# Building Permit Application

Permit No.: B15002558

RE: **Building Permit # B15002558**  
**5110 Honey Locust Court**  
**Ellicott City, Maryland 21042**

Further review is contingent upon submission of a revised building plan showing the following:

PRINT DATE: 08/18/2015  
SET NUMBER: 09RL99  
FIRST FLOOR PLAN

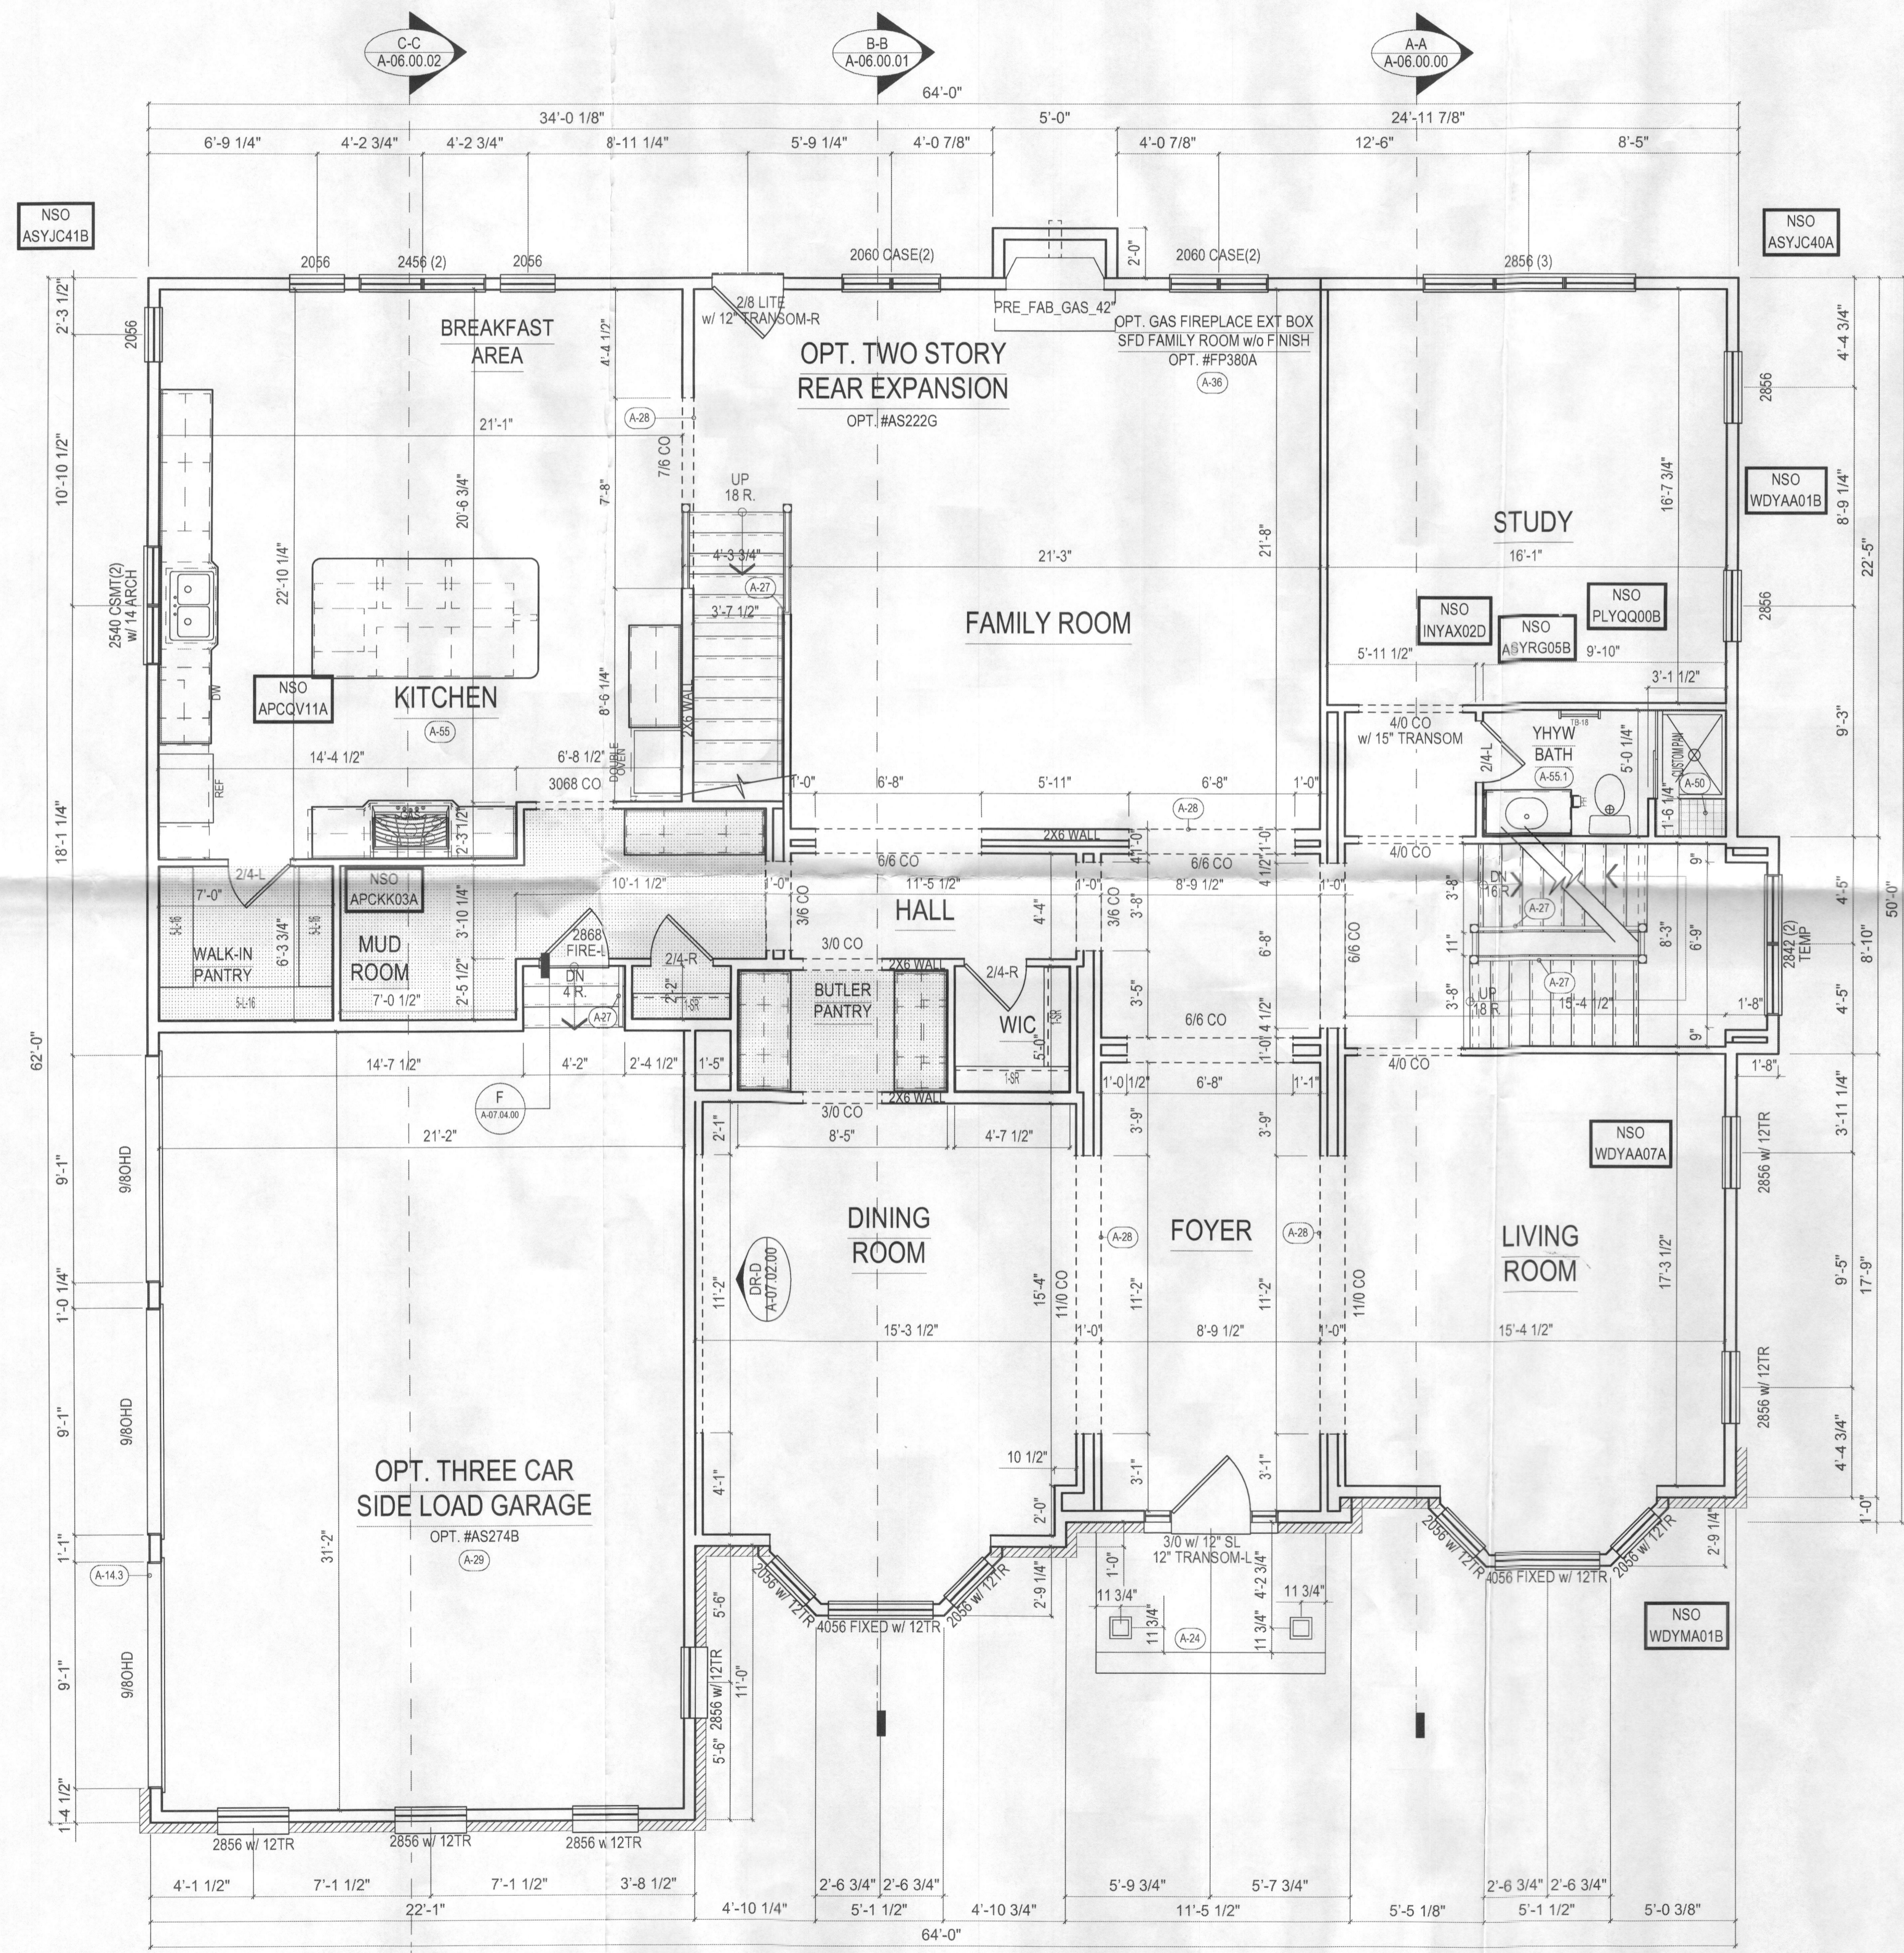
- Your floor plans reflect a 6 bedroom house and you are only allowed 5 bedrooms max on a shared system. Please resubmit a revised floor plan showing only 5 bedrooms.

REVISED  
Date: 8/26/15  
Comments: B1502558  
STUDY DOOR REMOVED FROM 1ST FLOOR LAYOUT PER HEALTH DEPT
